AA 0071-06 Pleasure Cove Marina

Site Plan
05-0068

Re: Pleasure Cove Marina
Modification #11120
B02265823, P 10-004400NA

April 27, 2010

BIORETENTION AREA #2 & DRAINAGE THROUGH MITIGATION
SCALE: (H) 1"=40'
(V) 1"=4'

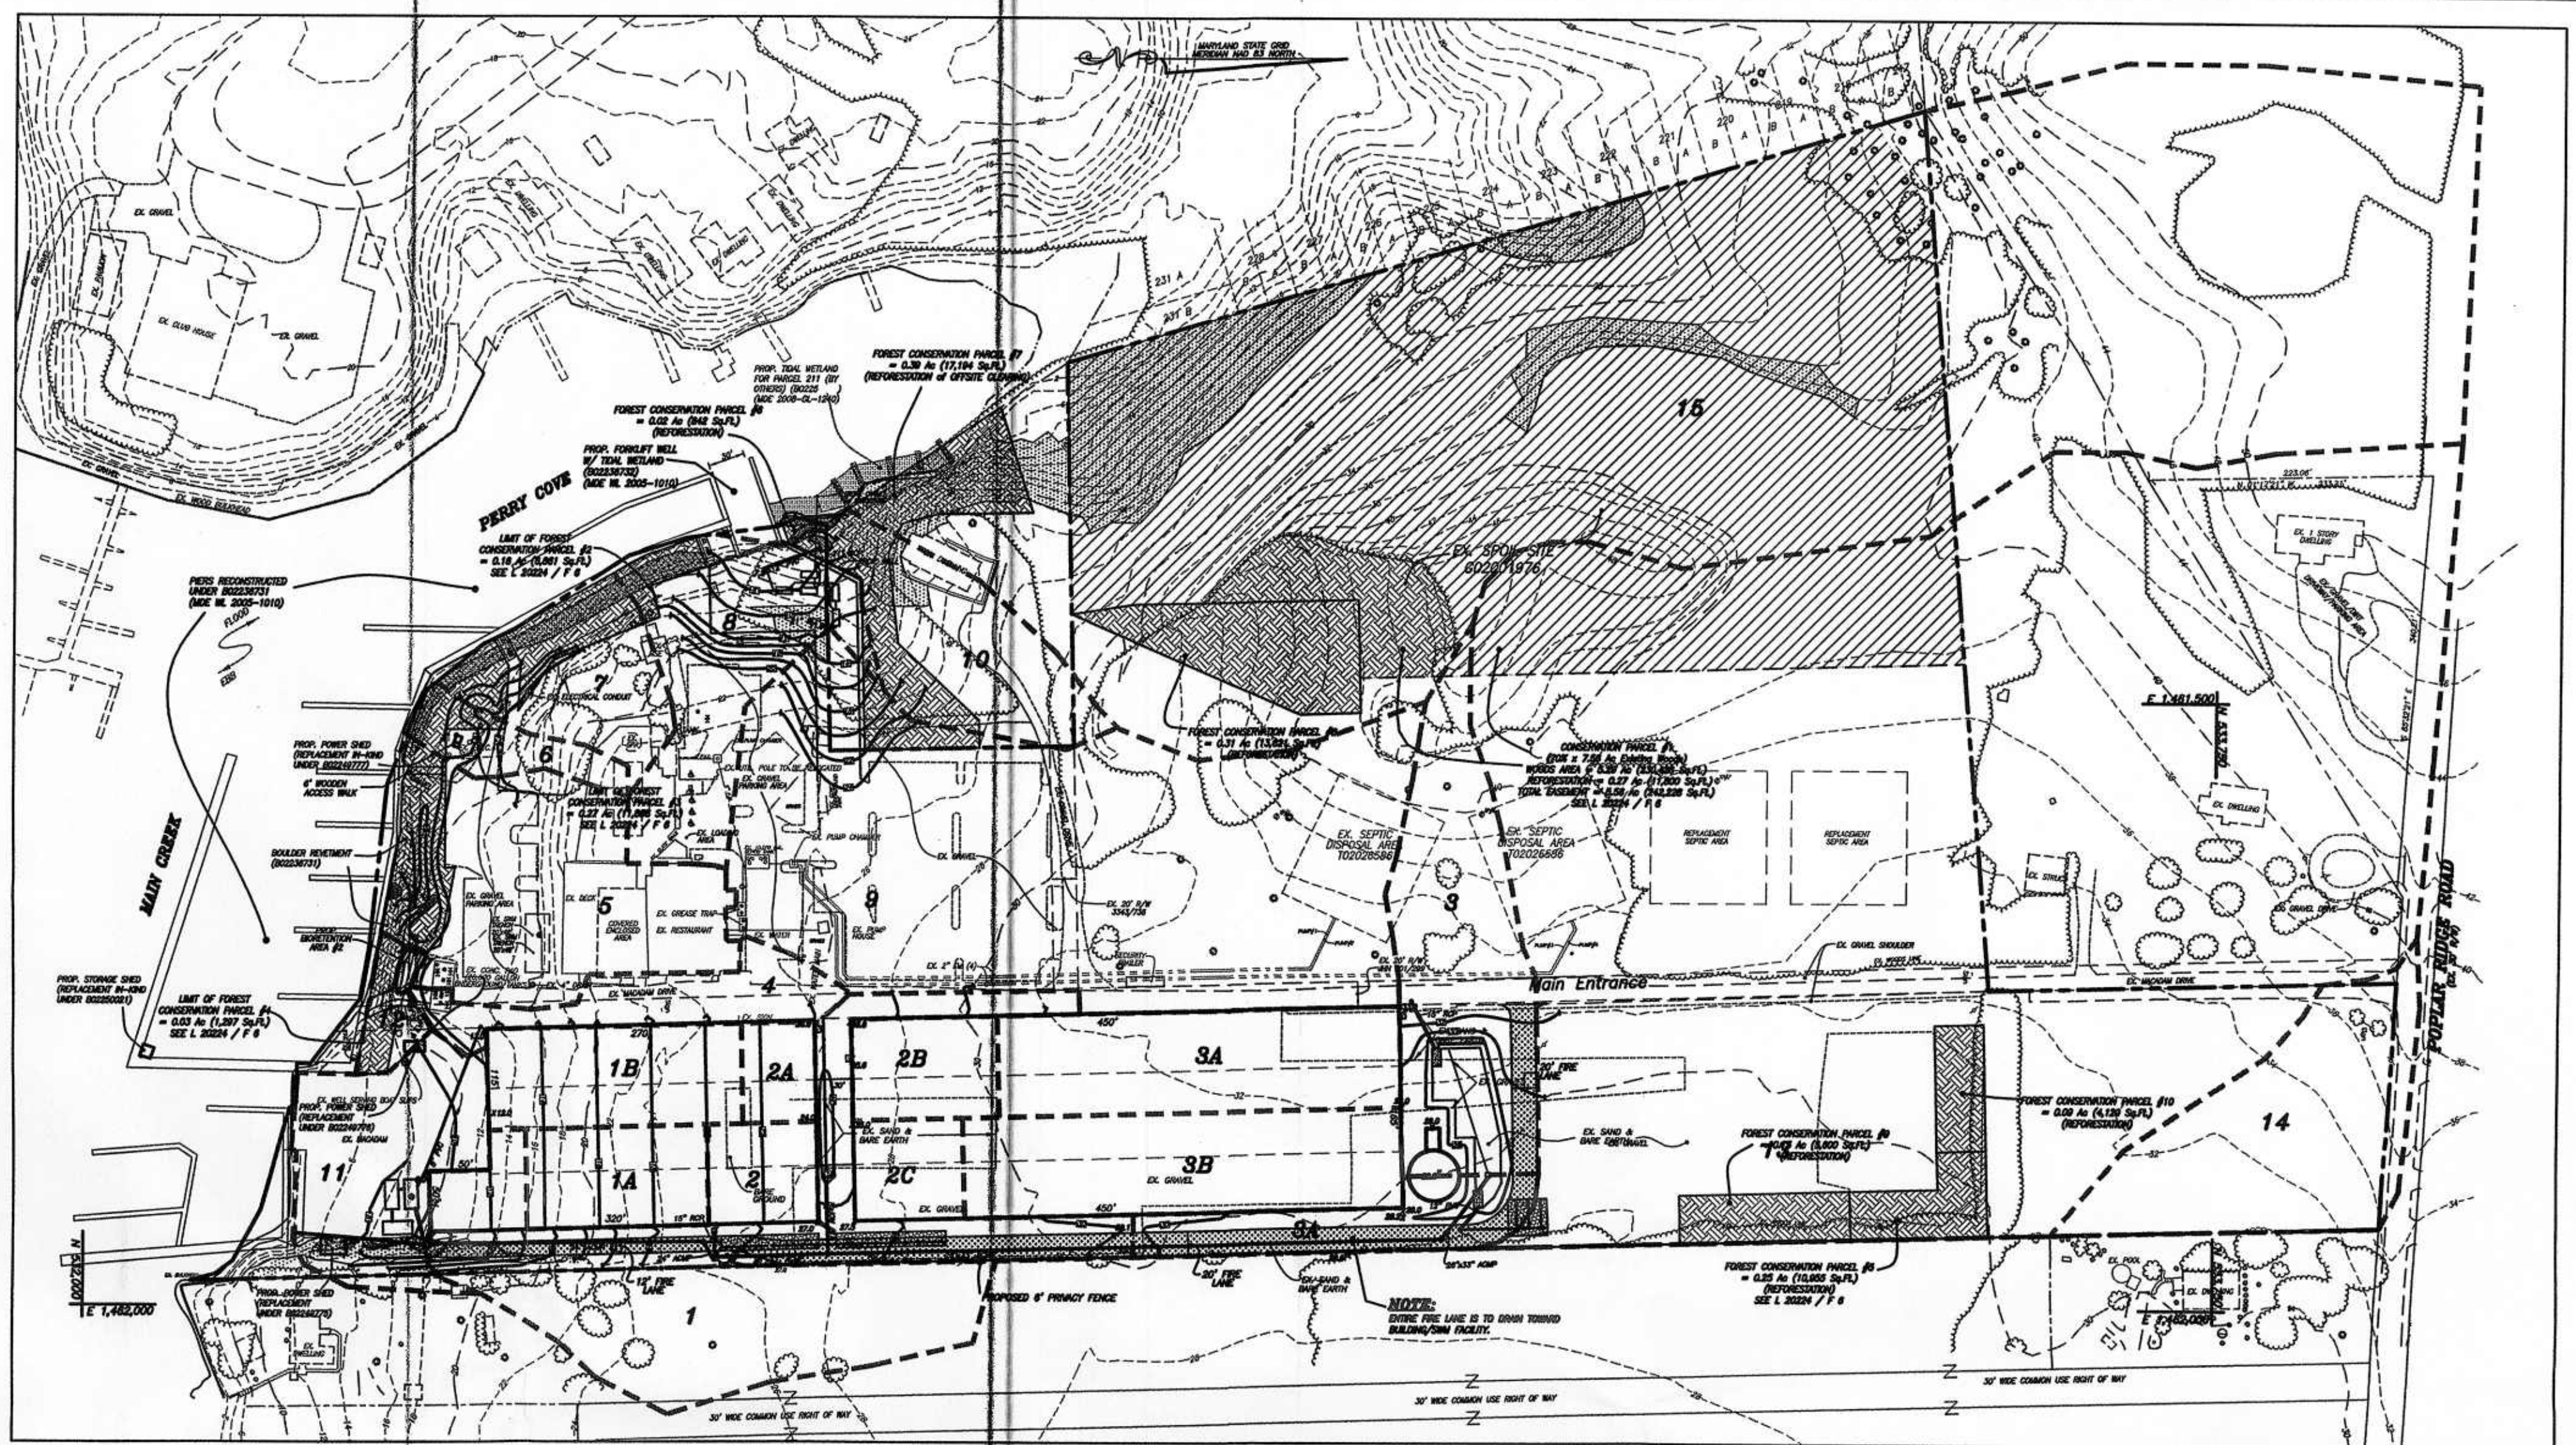
9. The dimensions shown on the bioretention section on sheet 5 of the plans do not agree with one another (i.e. the same dimension is 9' in at the top of the detail and 7' at the bottom of the detail) and do not agree with the dimensions called out in the swm report (i.e. 1.1 ft recharge storage depth on the plans vs. 2.9 ft in the calcs).

SDP Sheet# 22 of 25
GSC Sheet# 16 of 19

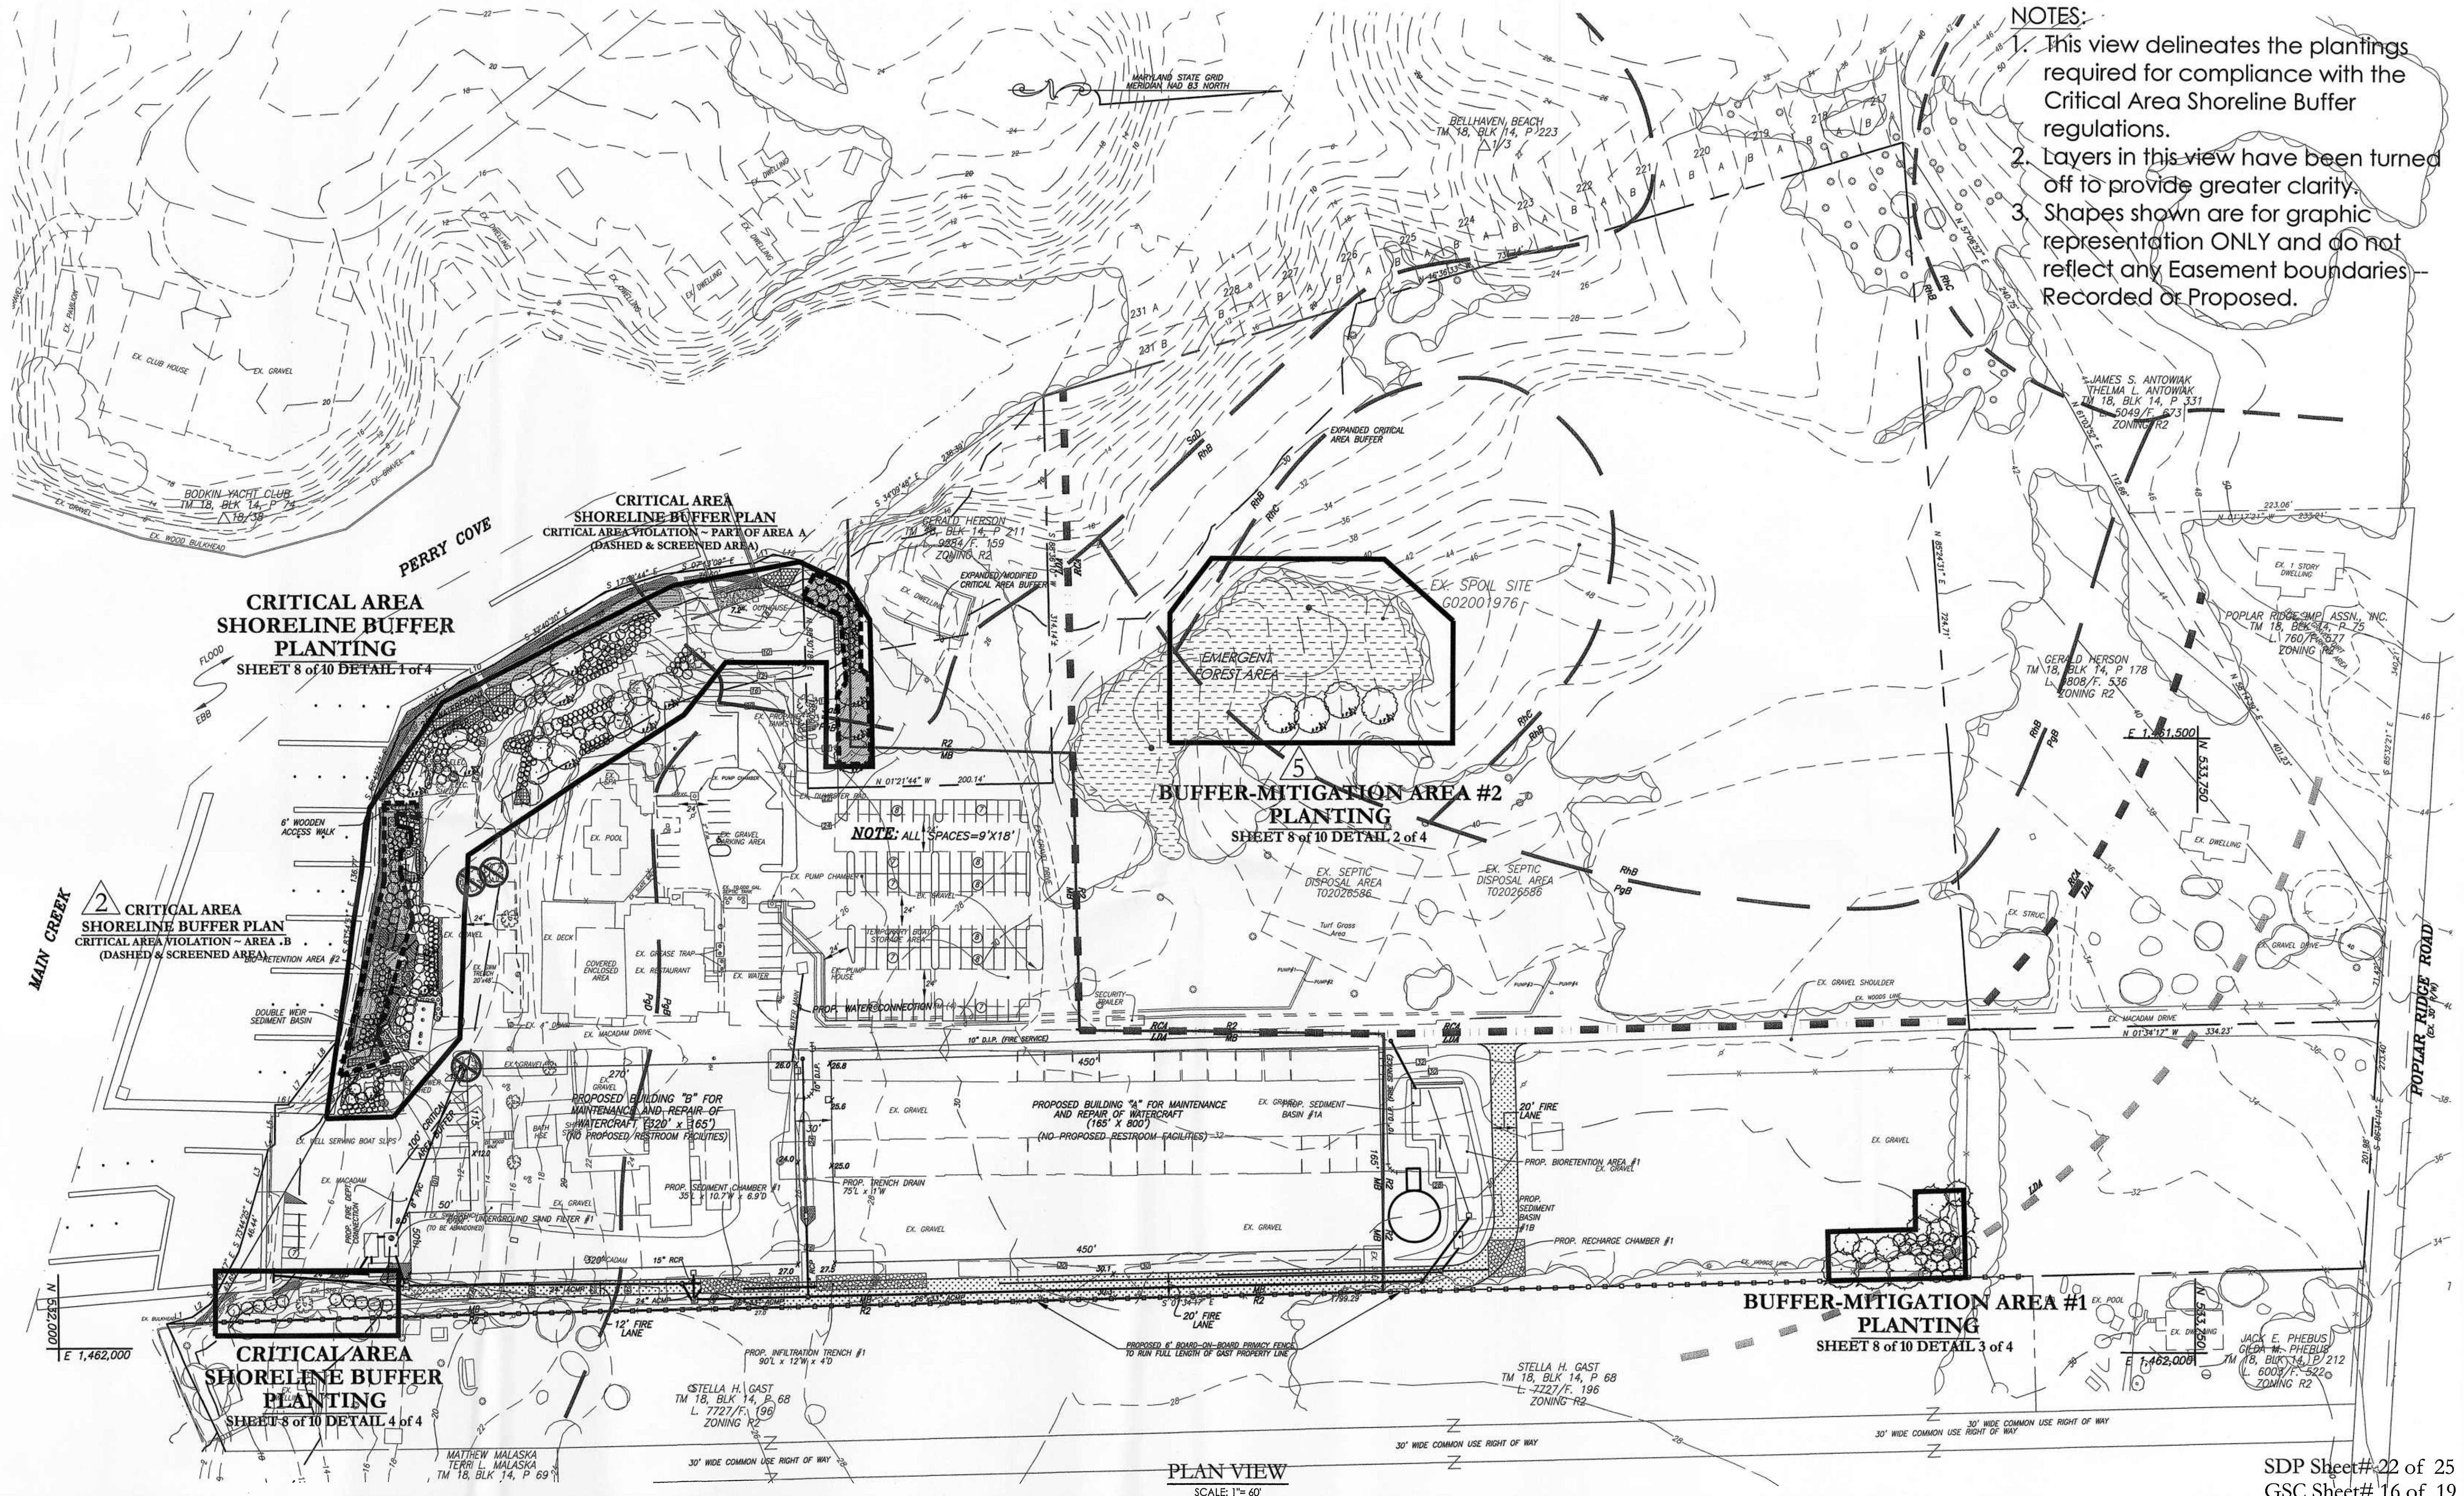
- try to see if can figure out where
15648 BMA plantings are provided
on sheets 22 + 23- 20723 sf decrease in lot cov. b/c
22, 362 sf parking removed north of
new road w/ landscaping areasvague about highest, says balance
care they landscaping areas that
were lot coverage? planting doesn't
make something not lot coverage. FOther Comments

4. The buffer limits have been revised.
5. The 25' buffer limit has been revised.
6. The number referenced (15,648 sf) is included in the total mitigation planting area that has been put under recorded easement (29,531 sf). This easement includes planting of the 25' buffer that was not previously planted as shown on in the calculations on the chart *Critical Area Buffer Planting Mitigation and Reconciliation Calculations* on sheet 23/25. The plantings are in multiple areas throughout this easement as shown on sheets 22/25 and 23/25.
